**Re: Letter of Notification of PPL Electric Utilities Corporation, Filed Pursuant to 52 Pa. Code Chapter 57 Subchapter G, for Approval to Rebuild the Existing Breinigsville-Alburtis 500 kV Transmission Line in Lehigh County, Pennsylvania
Docket No. A-2017-2635709**

Bureau of Technical Utility Services Data Requests
(Response dated 01/22/18)

**Figure 3-1: Aerial Overview Map
 Breinigsville-Alburtis
 500 kV Rebuild Project**

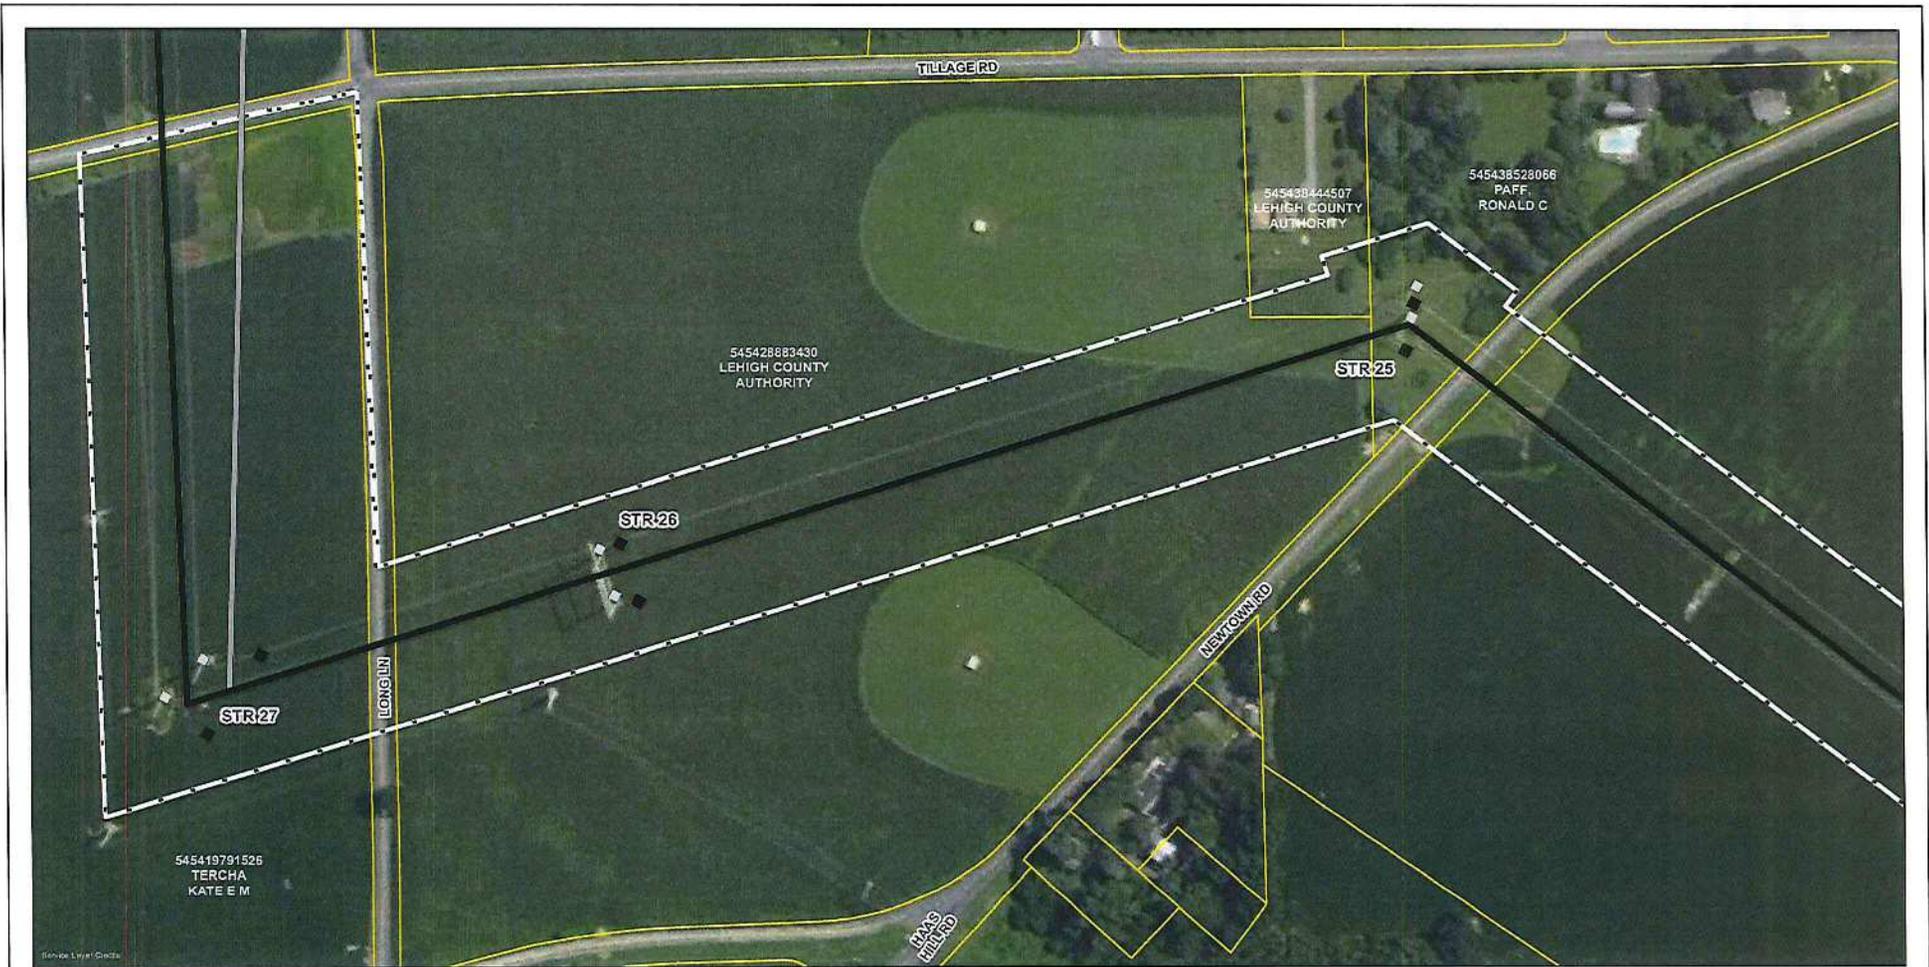
A-2 Reference the LON, Attachment 3, Figure 3-1 showing the proposed Breinigsville-Alburtis 500 kV rebuild project between structure 26 and structure 27. Please explain how this section of the proposed line will remain within the existing 200 feet right-of-way. In particular, on the Tillage Rd side of the ROW near Long Ln.

Attachment A-2 is an updated Figure 3-1 that shows how the alignment of the existing centerline coincides with the existing structures. The proposed lines will follow parallel alignments through this area and remain within the existing 200 feet right-of-way.
